#### **Addendum 13 – Regulation No. 14**

#### **Revision 5 - Corrigendum 1**

Corrigendum 1 to Revision 5 of the Regulation (*Erratum by the secretariat*)

#### **Uniform provisions concerning the approval of vehicles with regard to safety-belt anchorages, ISOFIX anchorages systems and ISOFIX top tether anchorages and i-Size seating positions**

Figure 2, correct to read:

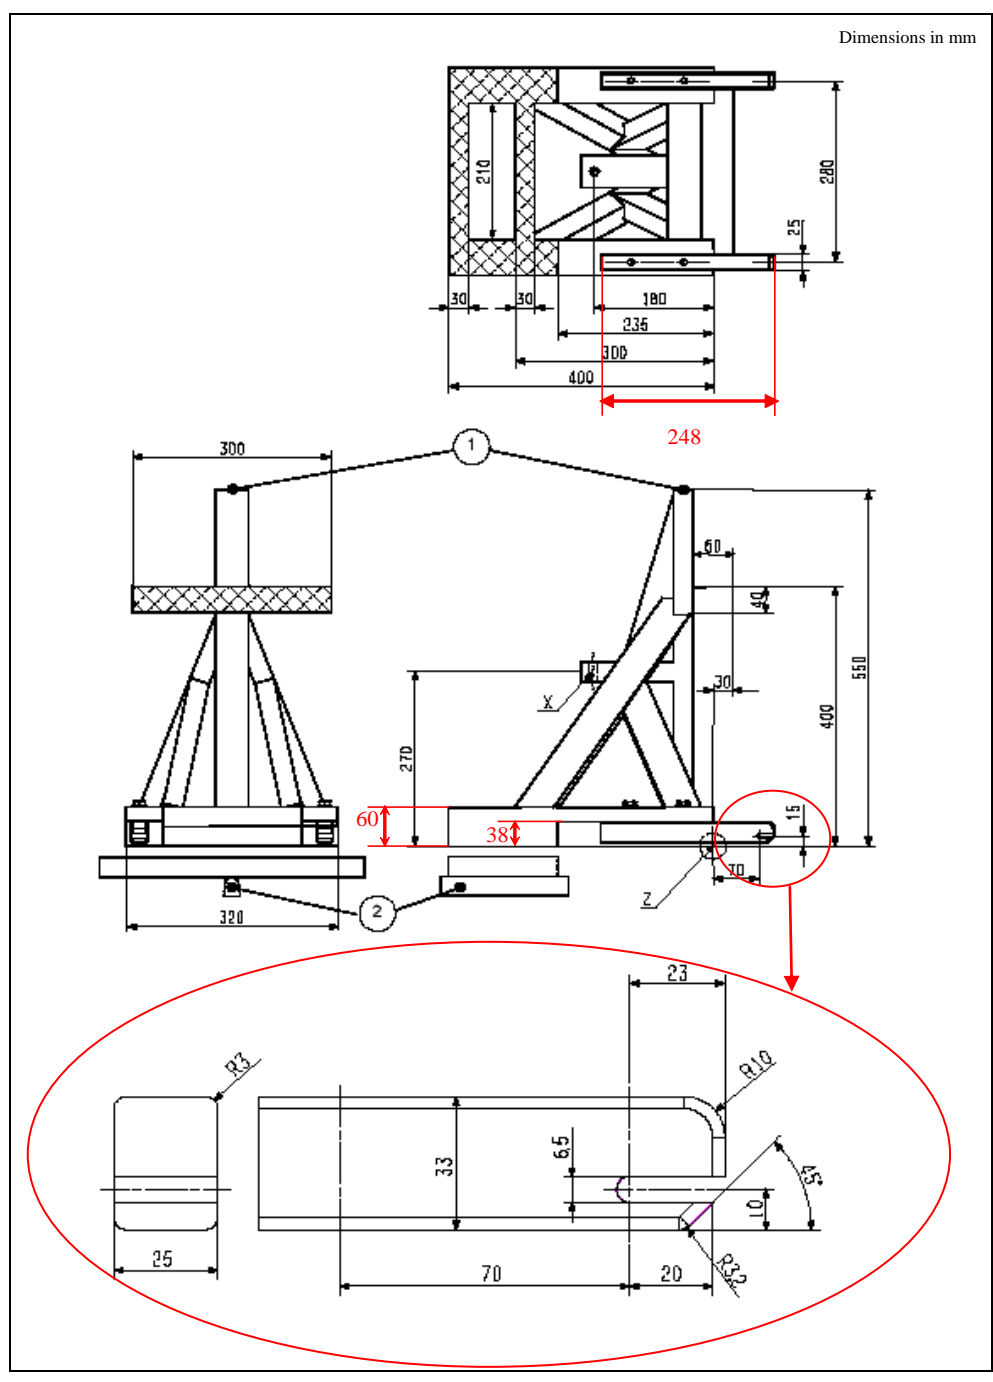
Annex 9,
